Project Address : 4311 7th Avenue NE
Seattle, WA 98105

Meeting Type : Administrative Design Review

SDCI Project # : 3030684-LU

Development Objectives

Prow and Glazed Balconies

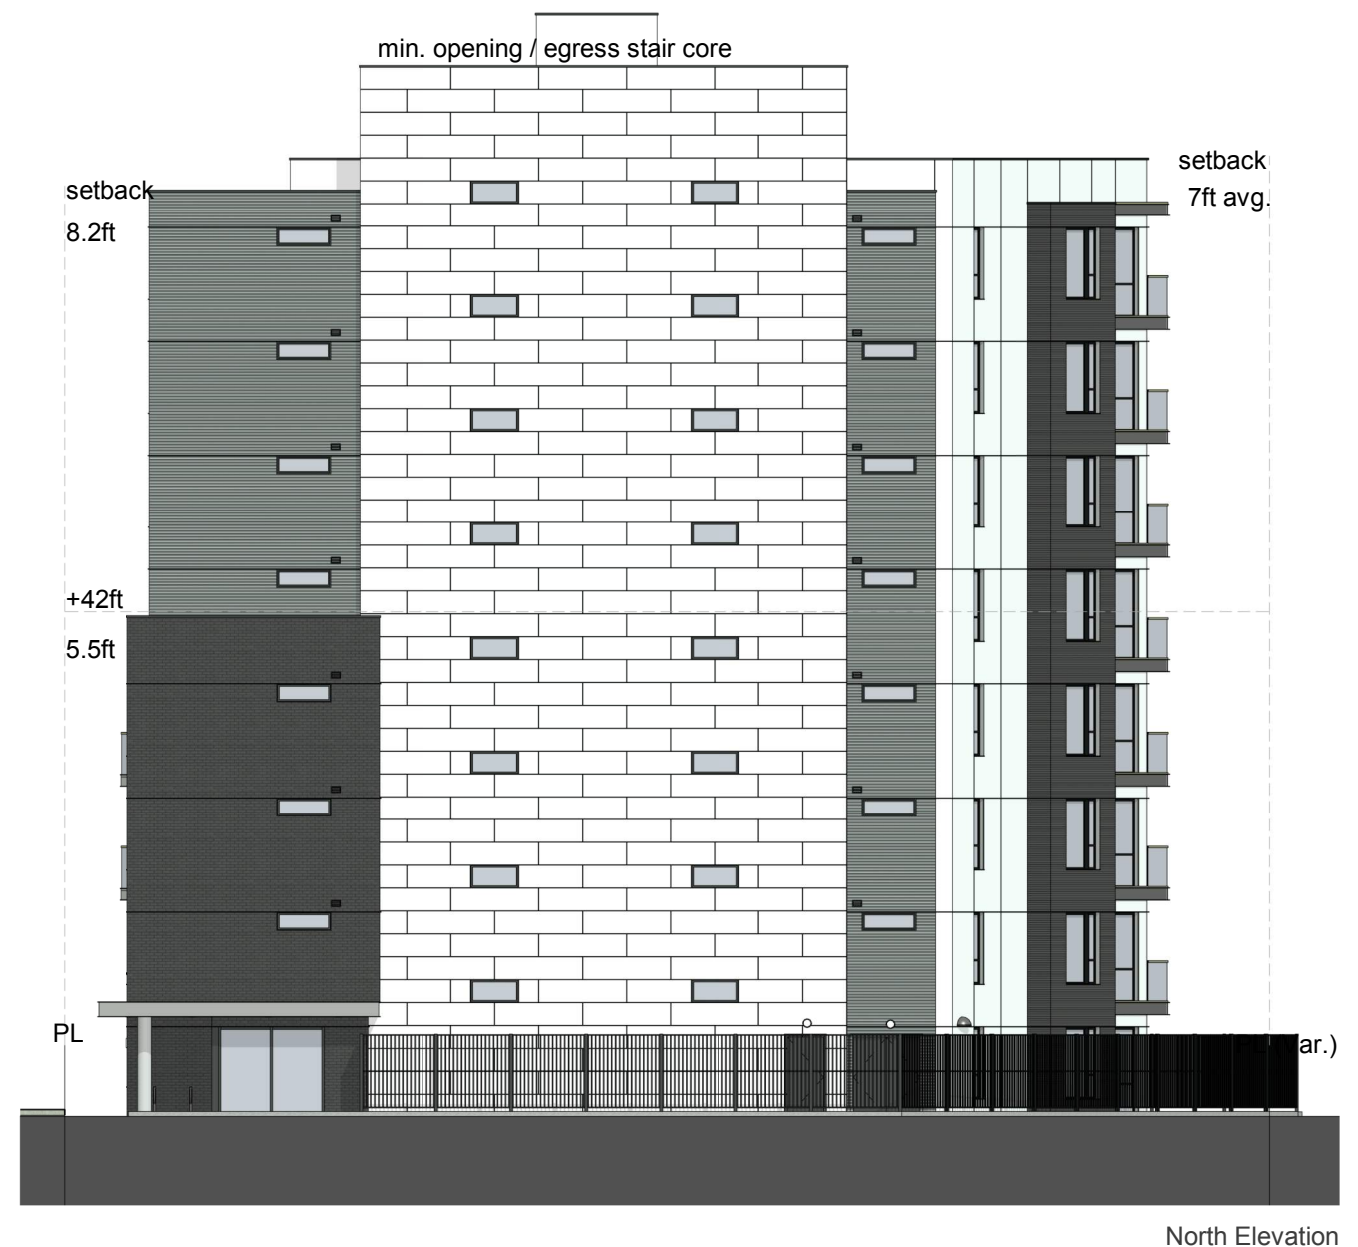
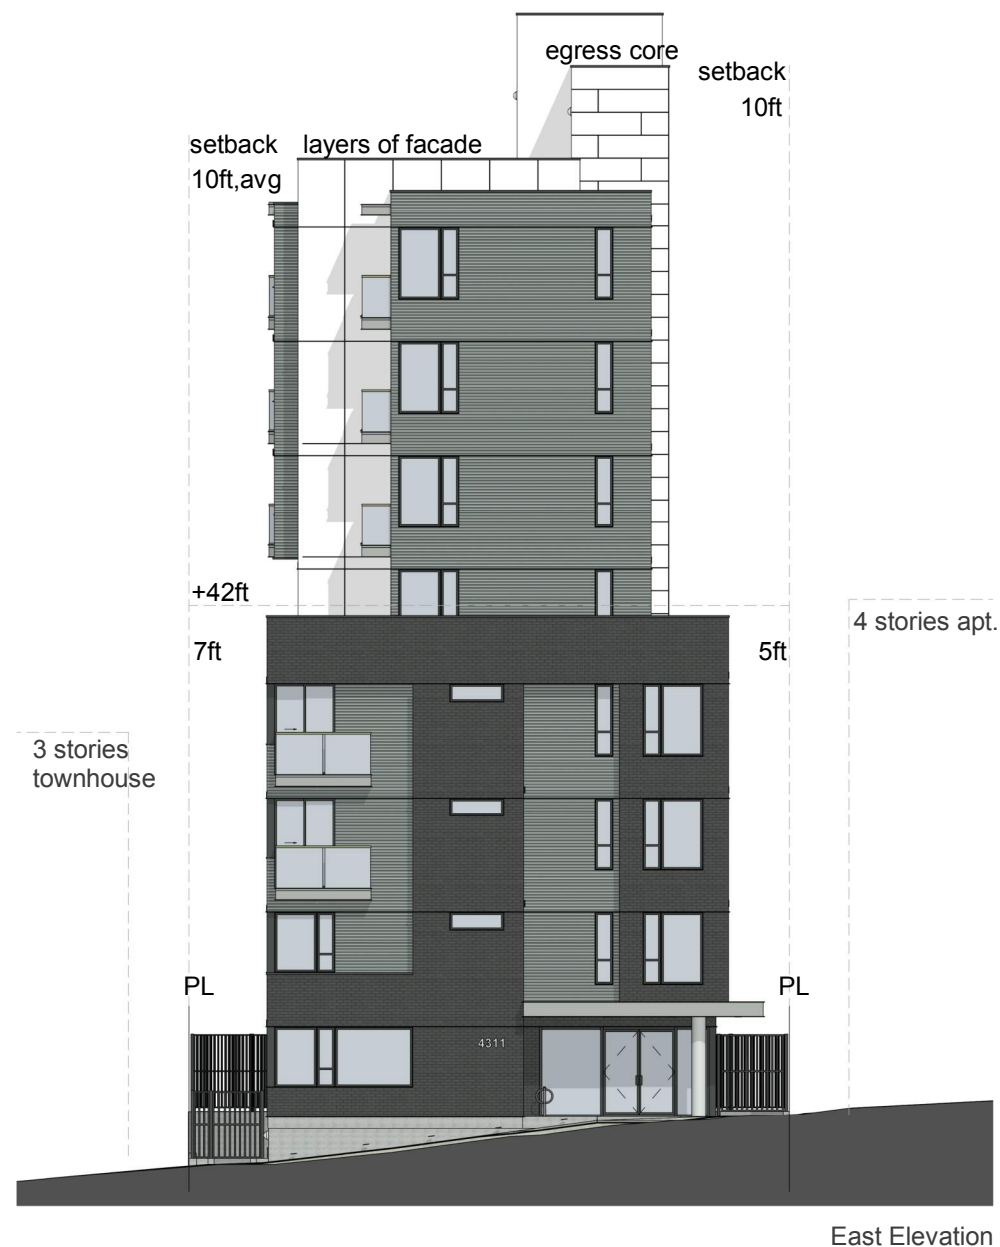
- a. Staff agrees that the applicant's preferred options represents blending of dynamic visual interest (with the freeway side prow concept) and human scale design along the street frontage along 7th Avenue. With the right detailing it has the potential to be a solid contributor to the urban life of the neighborhood and meet the required Design Guidelines. Making the prow and the street side meet in a visually coherent manner will be a challenge. The applicant should provide a study of the options considered for achieving this goal and an explanation of the treatment chosen at the Recommendation stage of review. **(CS 2 and DC2)**

- b. Better integrate the shape of the rooftop mechanical infrastructure so that it integrates and supports the overall design concept of the building. This could be achieved by mirroring the building's rear angles in its shape, for example, though other strategies could be successful. Enclosing the rooftop amenity would also allow the roof to be sculpted and allow for year-round use of the amenity. **(CS 3, DC 2, DC3)**

- c. Use the Bullitt Center (p 11) as inspiration for the inclusion of photovoltaic (PV) panels into the project. That project is successful because its interesting shape dictated in part by its sustainable features. This should be true of the proposal here as well. Make use of the proposal's oversize roof to include PV panels to meet guidelines relating to sustainability and building lifecycle. Be wary of the potential impacts of roof top PV to the over all design. They should be thoughtfully integrated in away that supports the massing concept and visual identity of the building. **(CS 1 and CS 2)**

- a. **Thin brick cladding and erosion of the brick volume for glazed balconies provides human scale, texture and visual interest on the 7th Avenue street frontage. Glazed balconies again erode the point of the prow on the freeway frontage, using the same language and a similar palette of materials to unify the two elevations.**
- b. **Rooftop mechanical has been eliminated from the rooftop; mechanical services to be provided from the basement level. It is infeasible to enclose the rooftop amenity, as this would constitute additional occupied building area per the building code and push from mid-rise to high-rise construction.**
- c. **Preference for daylight is given to the green roof and rooftop amenity space. PV panels will be accommodated on lower roof features where it will not shade the green roof or amenity space.**

Northeast main entry view

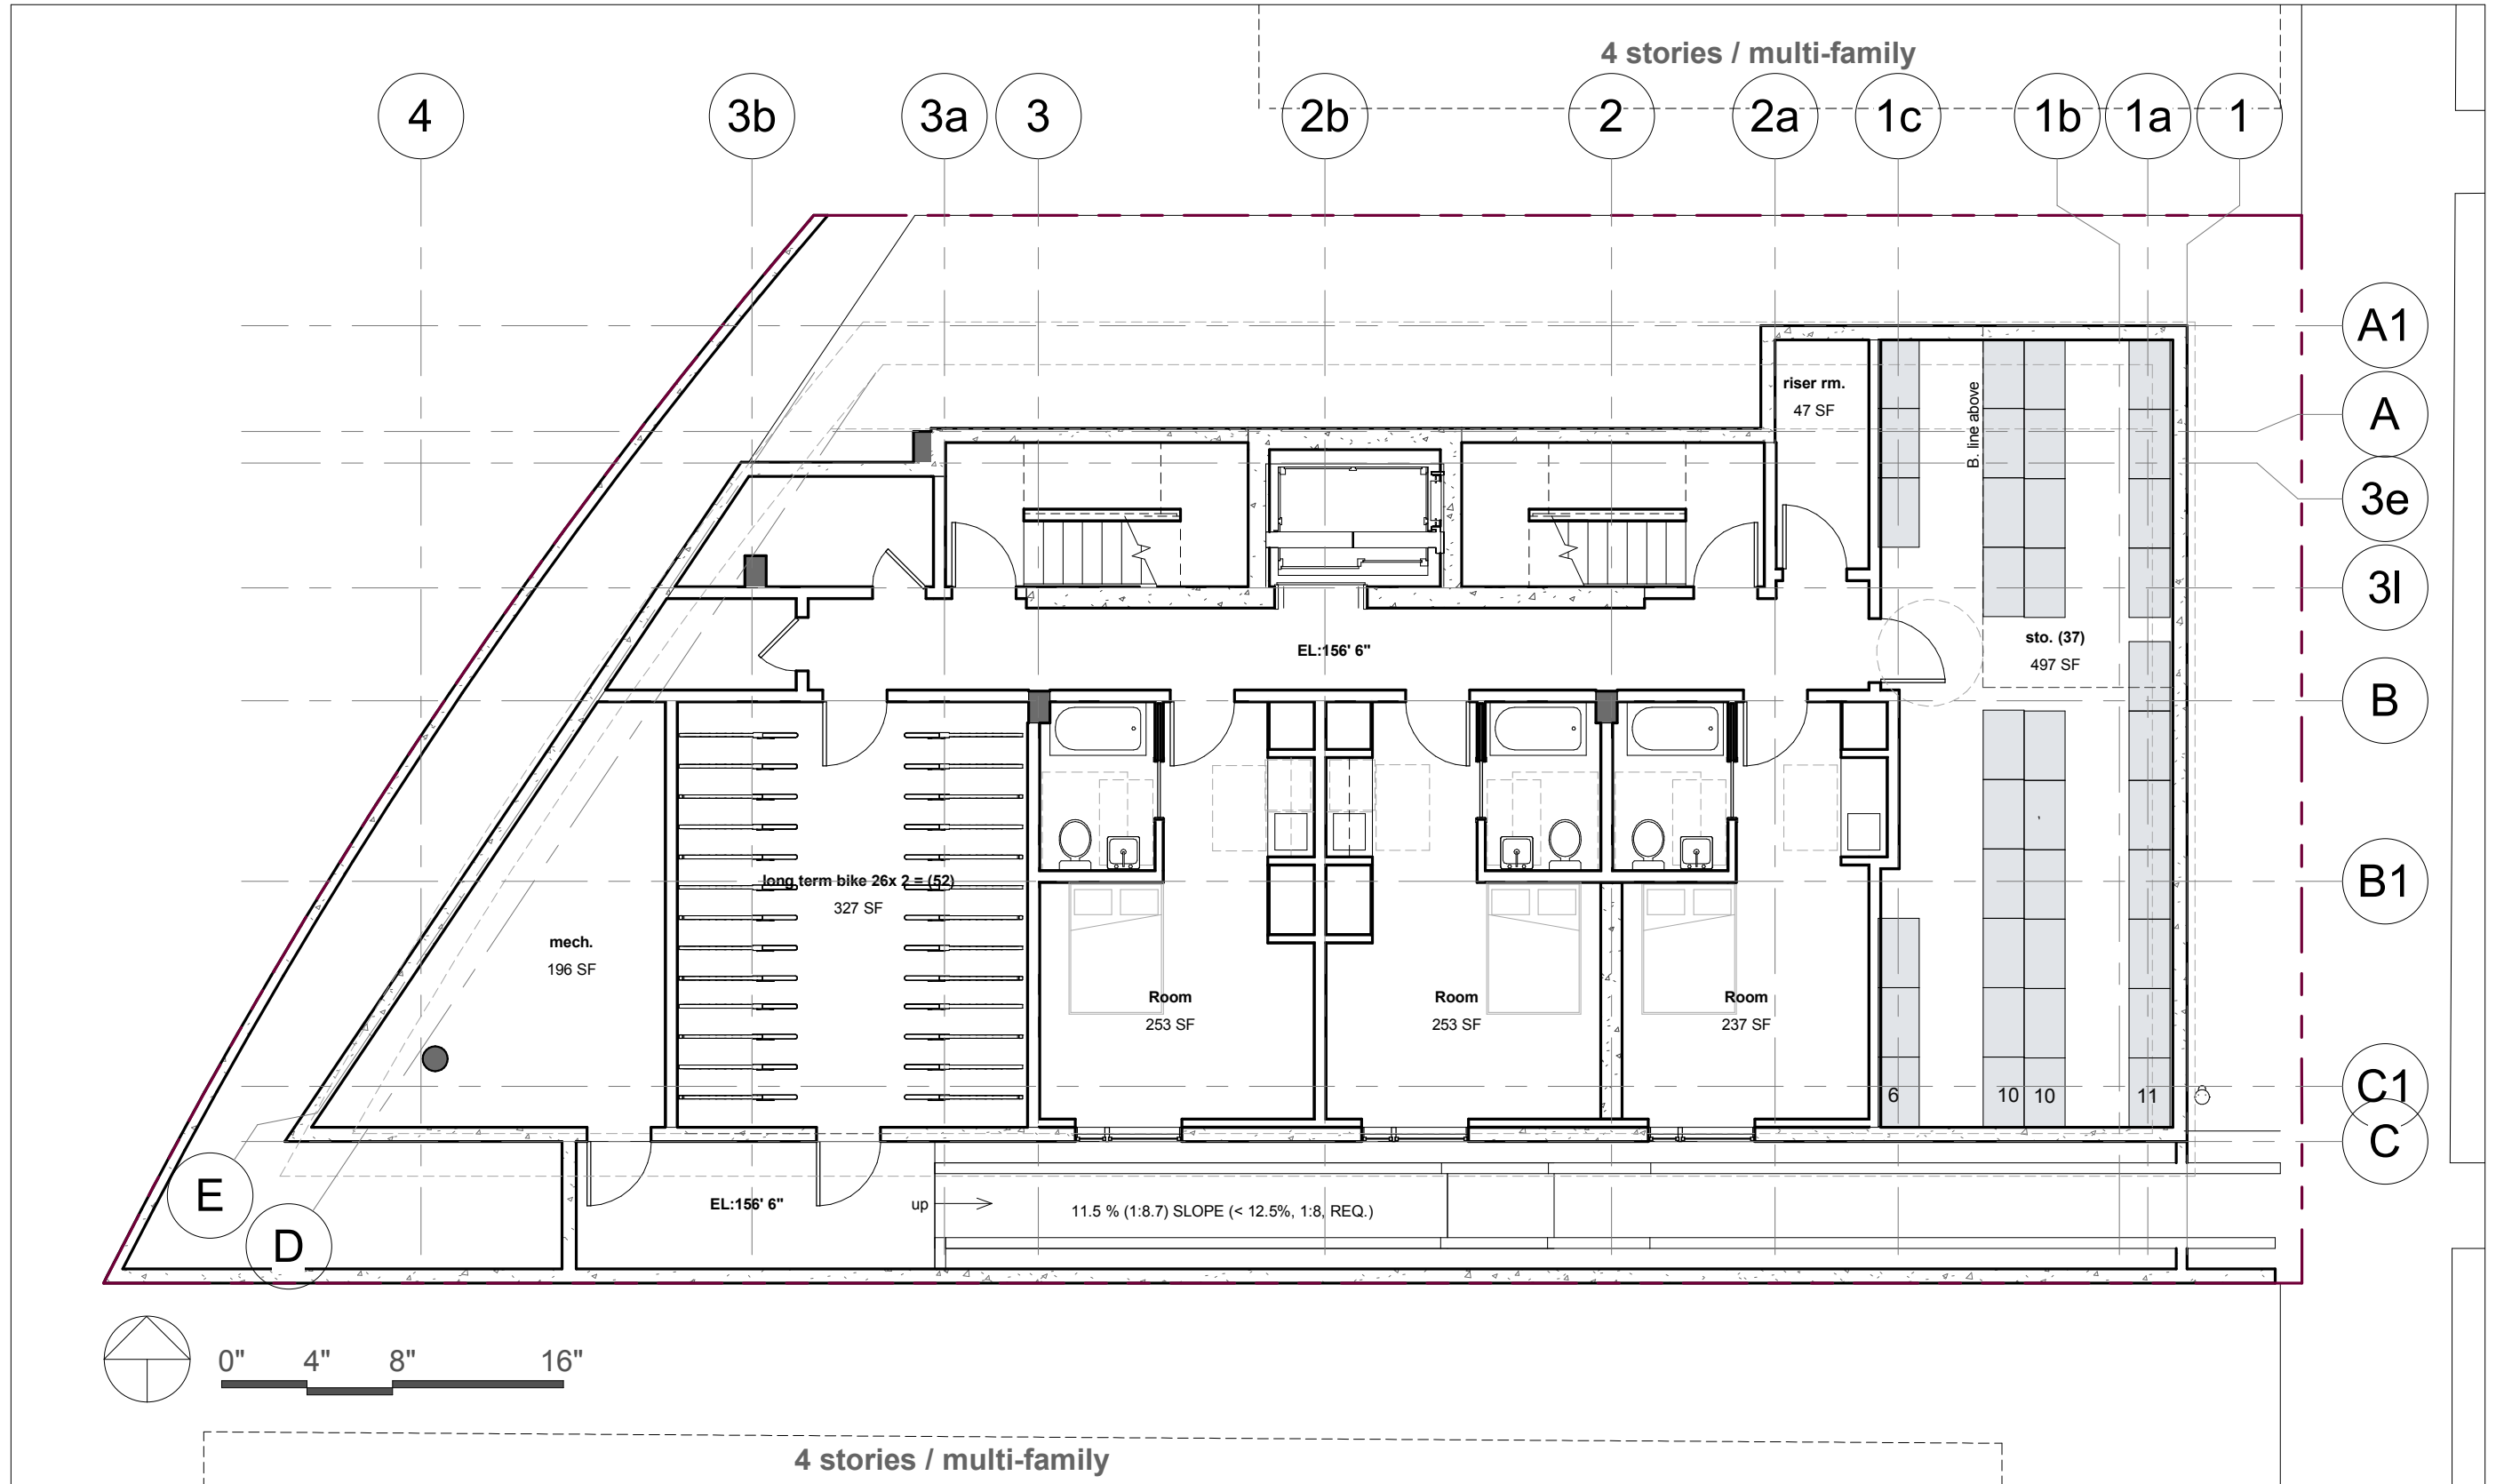
- Rearrange the interior uses of the preferred option to support a dynamic street frontage. Restrooms along street frontages are not successful. Their privacy requirements limit the amount of glazing necessary to connect the interior of the building with the public realm. Consider placing a larger lobby on the first floor, building amenity or at the very least switching the unit restroom to the other wall. Consider putting the amenity in place of this unit and creating a basement unit with a generous lightwell below the amenity space. **(PL 3 and DC1)**

- Increase the amount of glazing on the 7th Ave ground floor façade. **(PL 3)**
- Staff encourages the applicant to be thoughtful about the placement of windows on the side elevations of the building. Provide a window study examining the proposed locations of windows and their position relative to the windows of neighbors. **(DC1 and CS 3)**

- The ground-level lobby has been reconfigured to take advantage of the street frontage, and restrooms located toward the interior core. The basement has been reconfigured to provide three living units with good lightwell daylighting, in addition to building storage and services.*
- The lobby and amenity space has increased glazing to provide inviting transparency.*
- Refer to sheet 11.04 for fenestration study. Every effort has been made to minimize overlap between windows on the lower south facade of the proposed building and windows of the adjacent building.*

South - MUP- Dep. 1/16" = 1'-0"

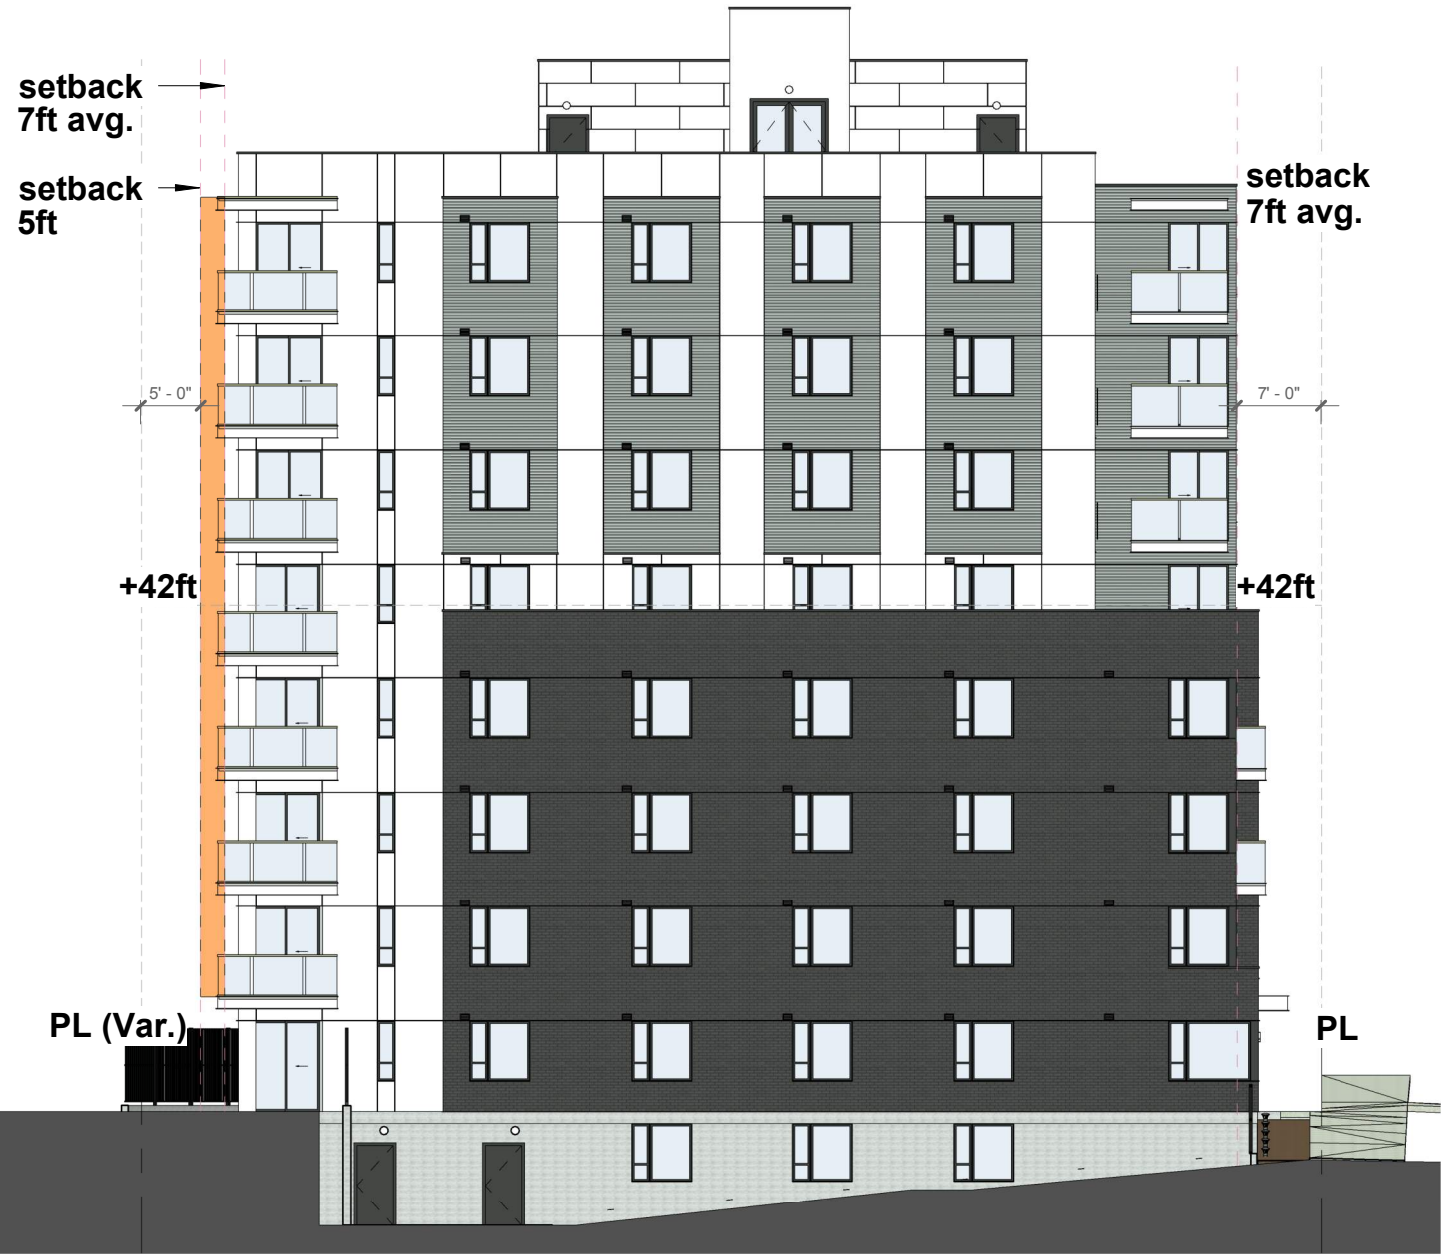
1. Rear setback reduction (23.45.518, Table B): The Code requires an average of 7 ft setback with a 5 ft minimum above 42 ft and a 10 ft average setback with 7 ft minimum below. The applicant proposes that the setback be reduced to 5 ft below 42 ft and 5 ft above with a 7 ft average.

Staff supports the requested departure. Moving mass away from the front of the building supports a human scale street frontage along 7th Ave. Pushing the mass to the rear of the site has little negative impact since its backs on to a busy freeway. The proposal makes use of this allowance to create a strong, prow-like visual presence that is scaled to the passing freeway and meets guidelines pertaining to architectural character and design concept. (CS 2 and DC 2)

We are asking for a departure to reduce the western side setback above and below 42 feet. And for the set back below 42 feet to be reduced from 7 foot average / 5 foot minimum to 5 feet. At 42 feet and above asking to reduce from 10 foot average / 7 foot minimum to 7 foot average / 5 foot minimum. This departure allows the upper four stories of the building to essentially shift to the west without the loss of floor area, increasing the setback along 7th Ave NE above 42 feet. The larger setback on 7th helps to reduce the bulk of the building by stepping back from the street creating a four story podium which better responds to the scale of the adjacent buildings. In general we feel that a stepped setback can be more effective at responding to the neighborhood context along the street than at the i5 corridor which has no pedestrian experience.
